## ADDENDUM #3

**Date Issued: March 27, 2018**

**NEW HAVEN PUBLIC SCHOOLS  
SCHOOL CONSTRUCTION PROGRAM**

ROOF DETAILS

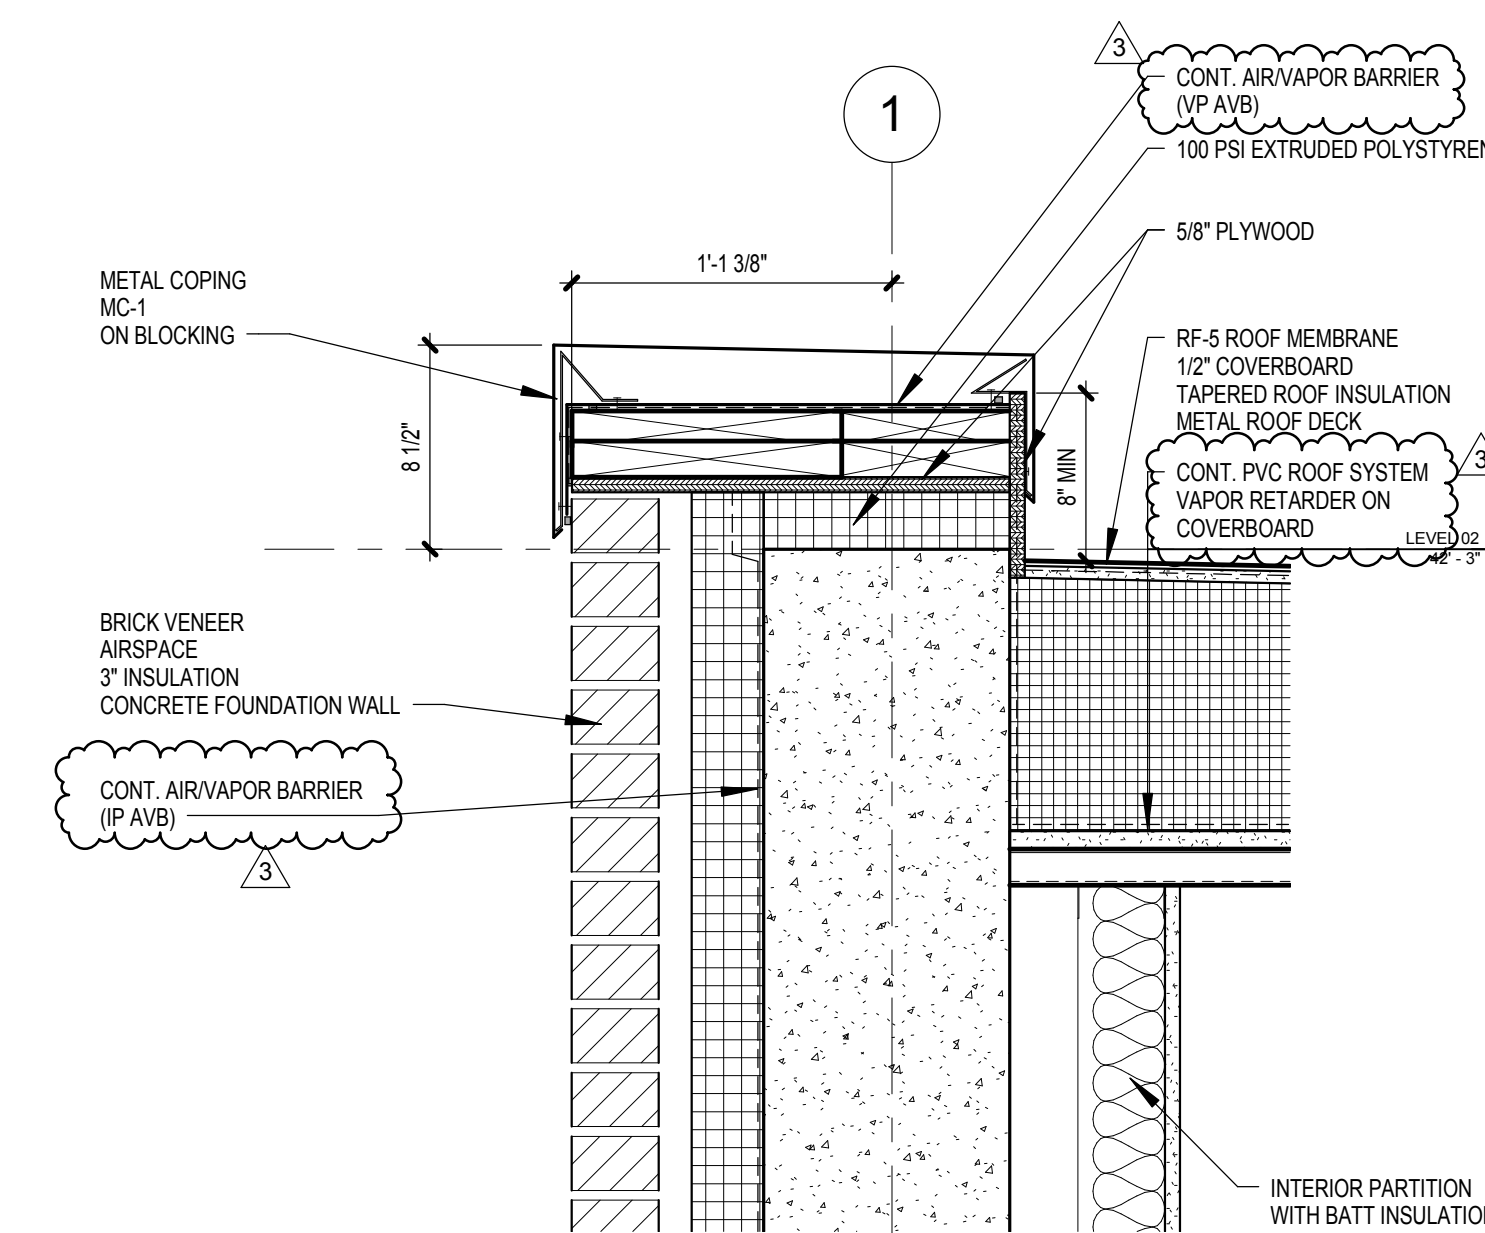
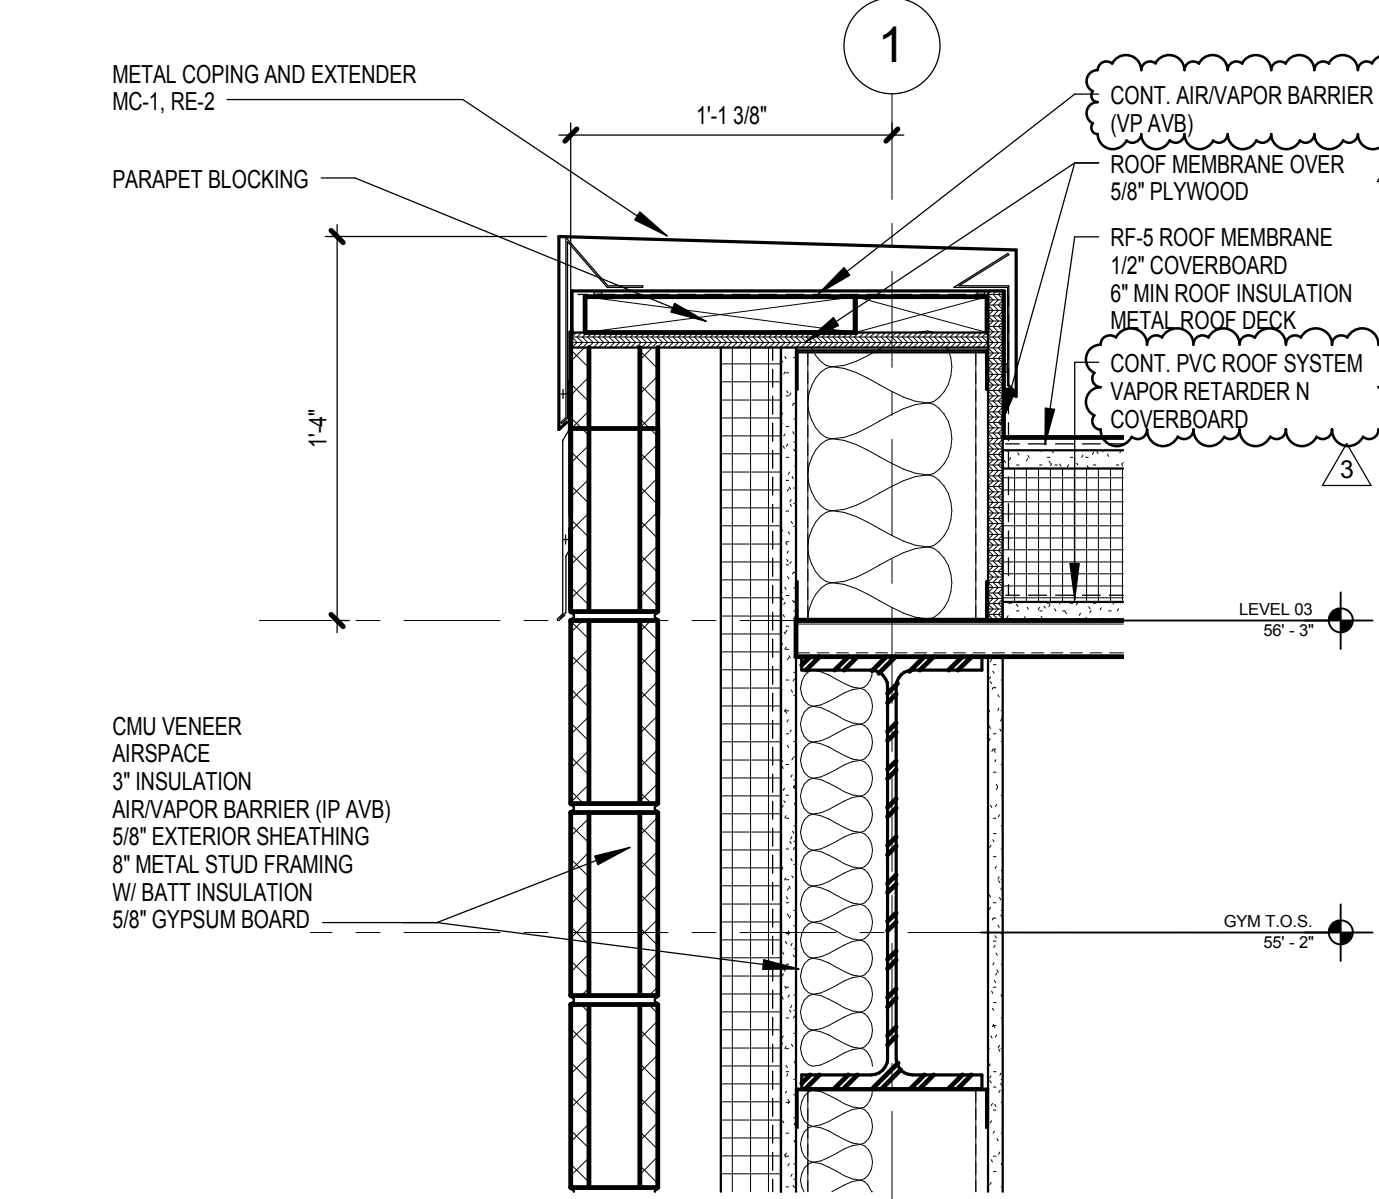
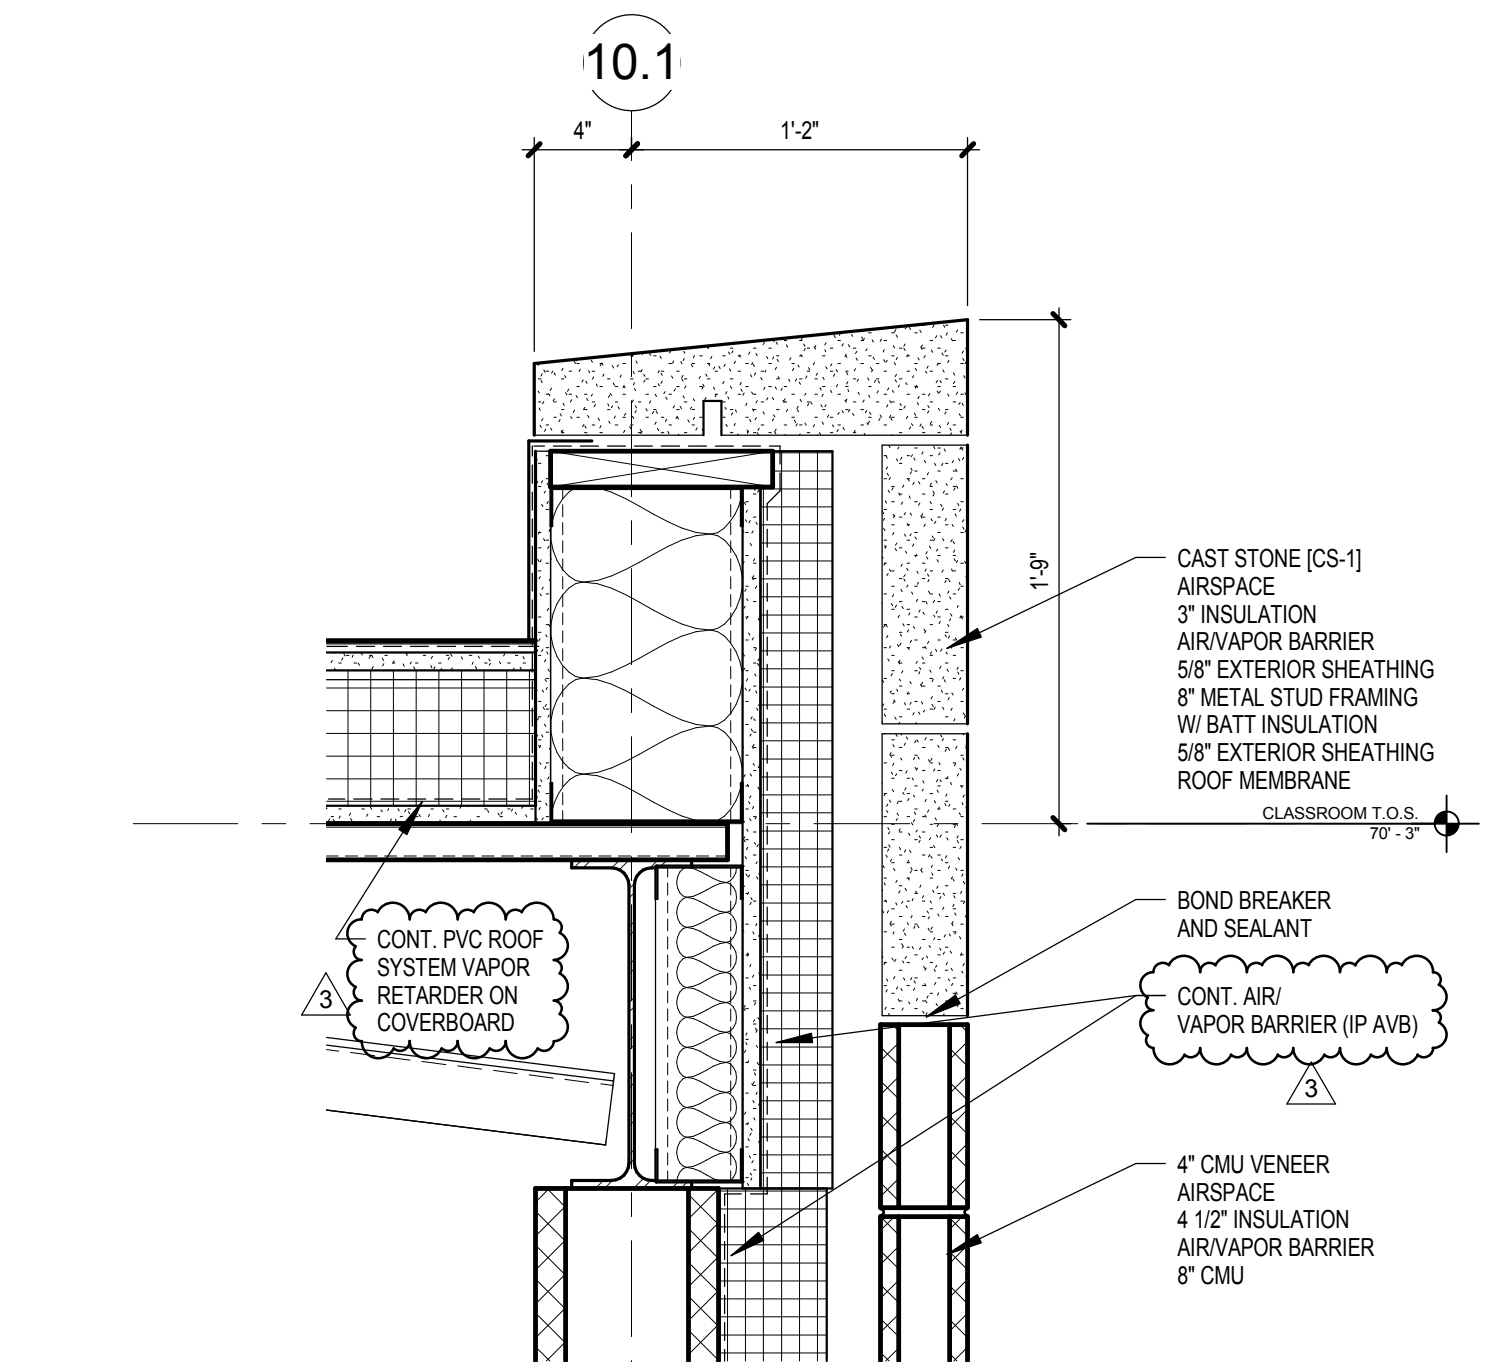
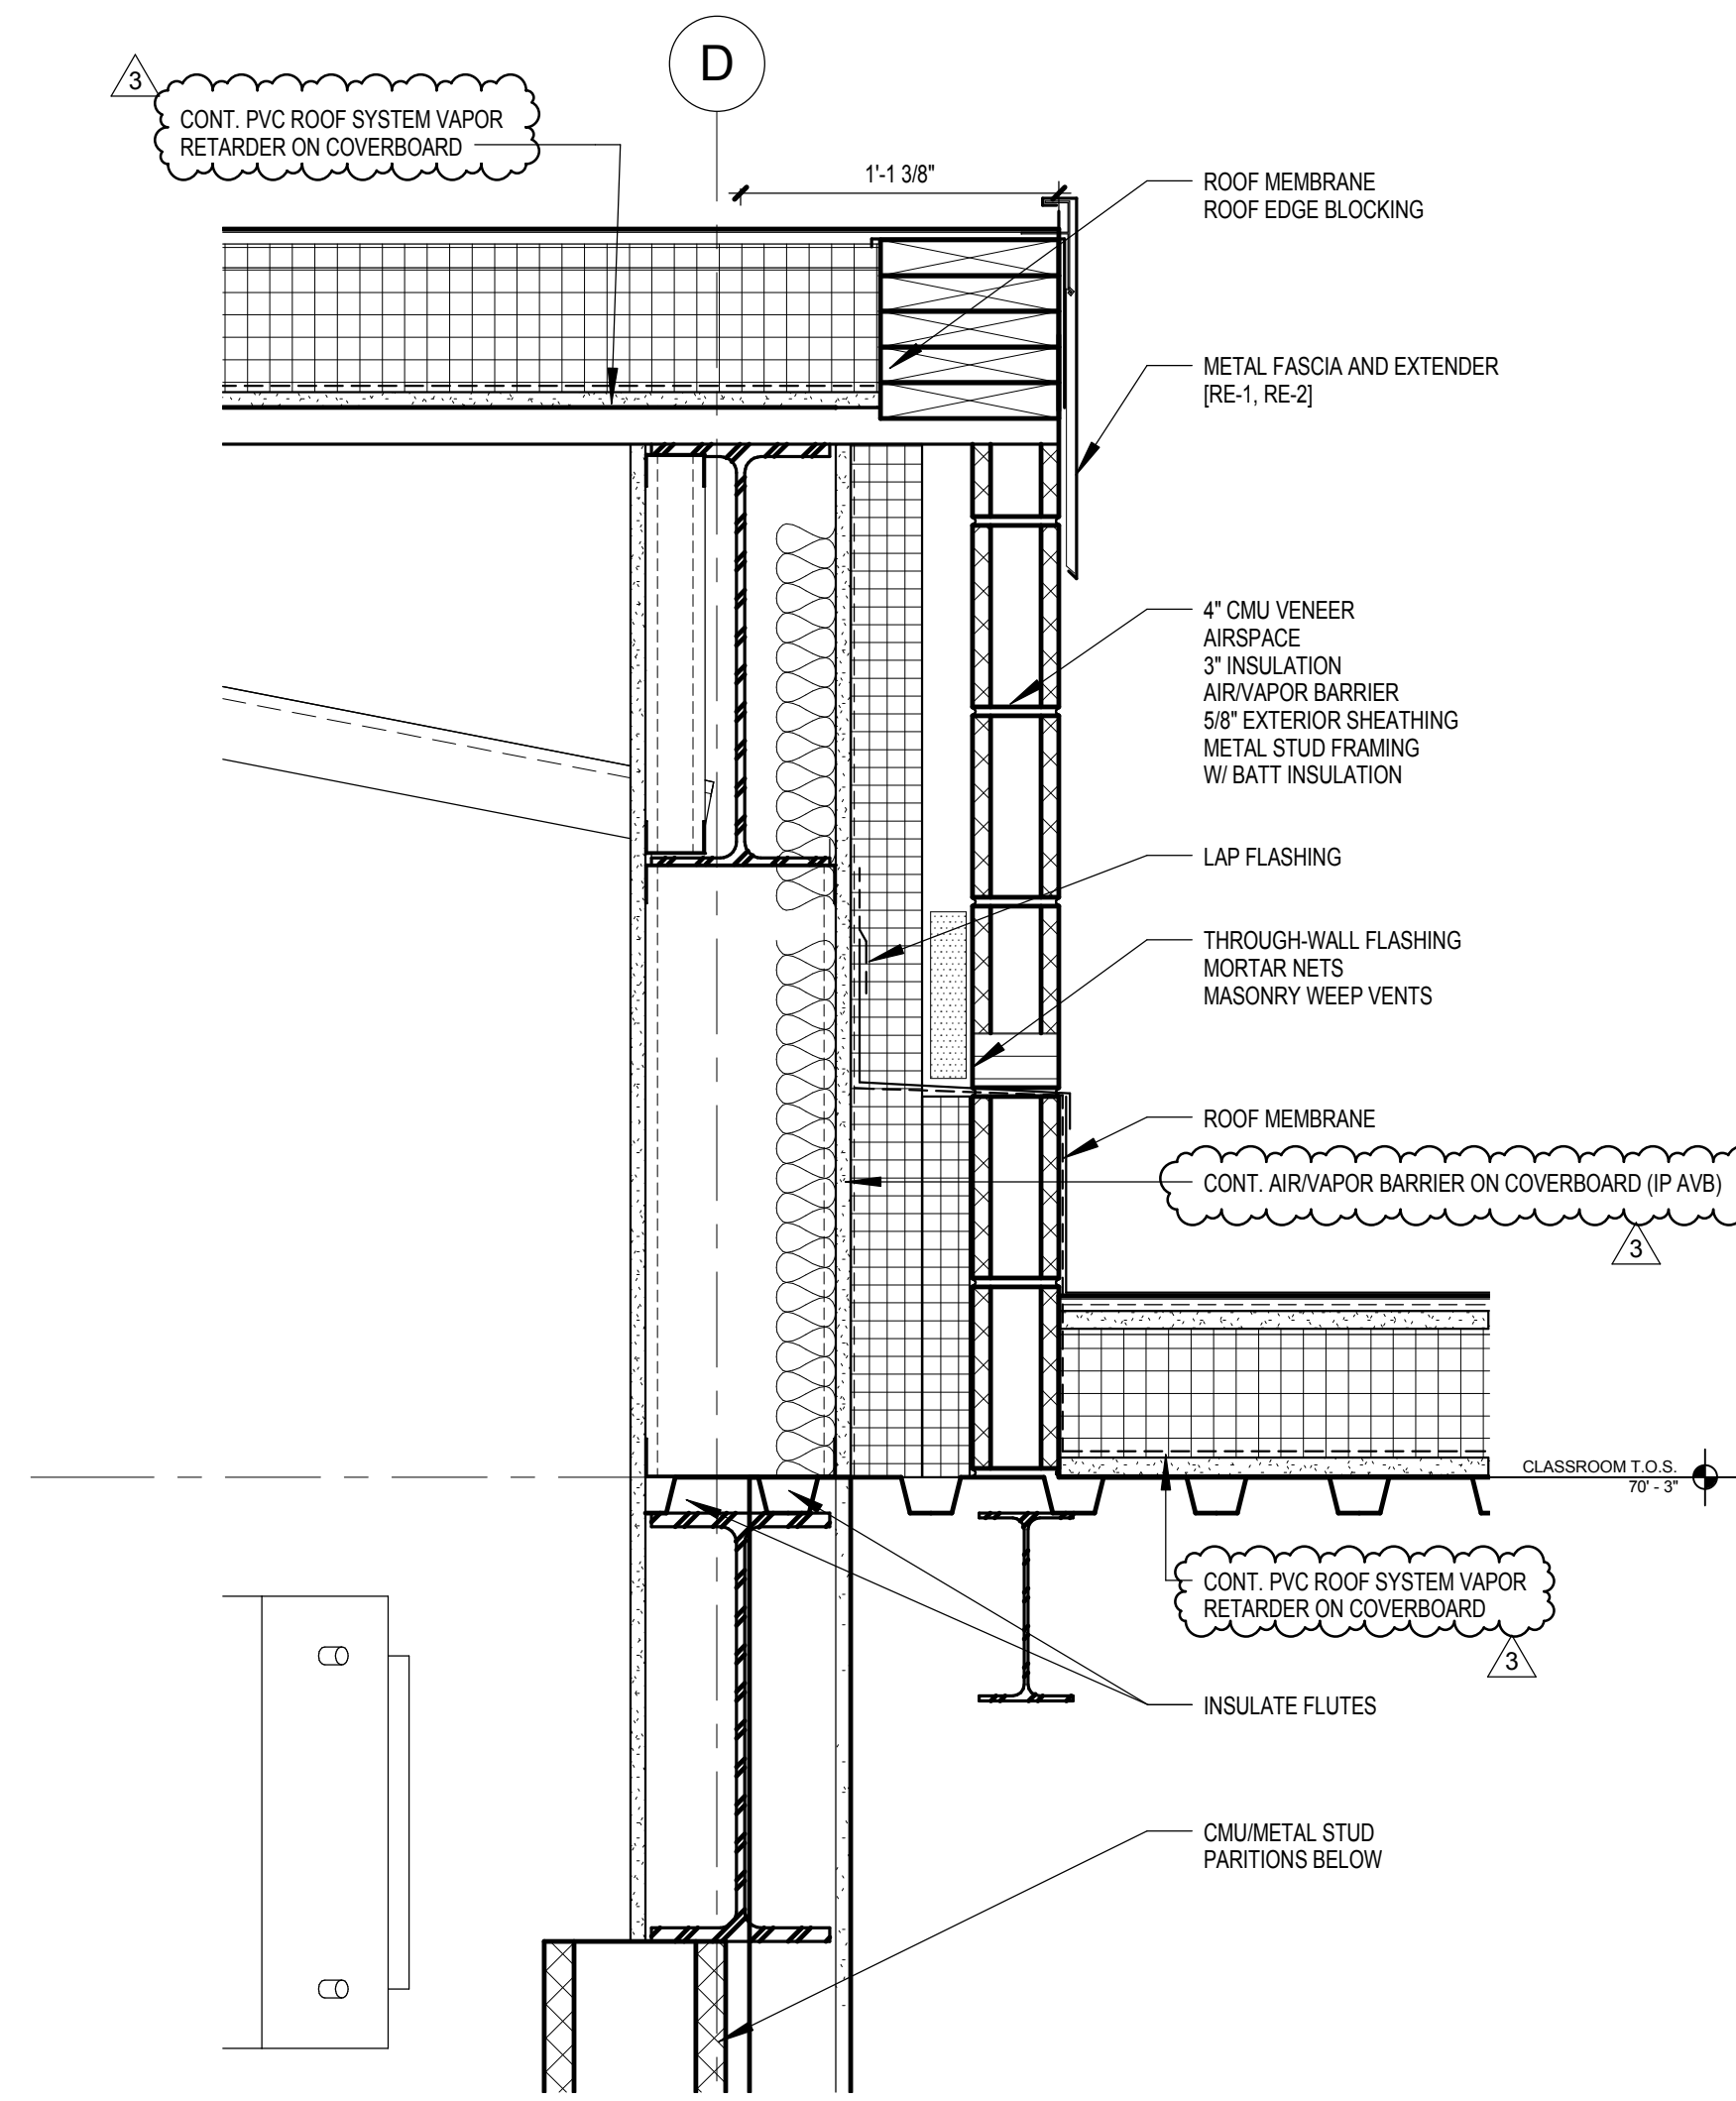
- A-520: Revised details to clarify roof system AVB
- A-521: Revised details to clarify roof system AVB
- A-522: Revised details to clarify roof system AVB

Can you please confirm the "VP Vapor barrier" as shown in typical detail 4/A521 is by others and the "IP Vapor barrier" is by the roofer?

12. A-521: Revised details to clarify roof system AVB
13. A-522: Revised details to clarify roof system AVB
14. A-550: Modified details 13, 16 & 18 to indicate correct ceiling type.
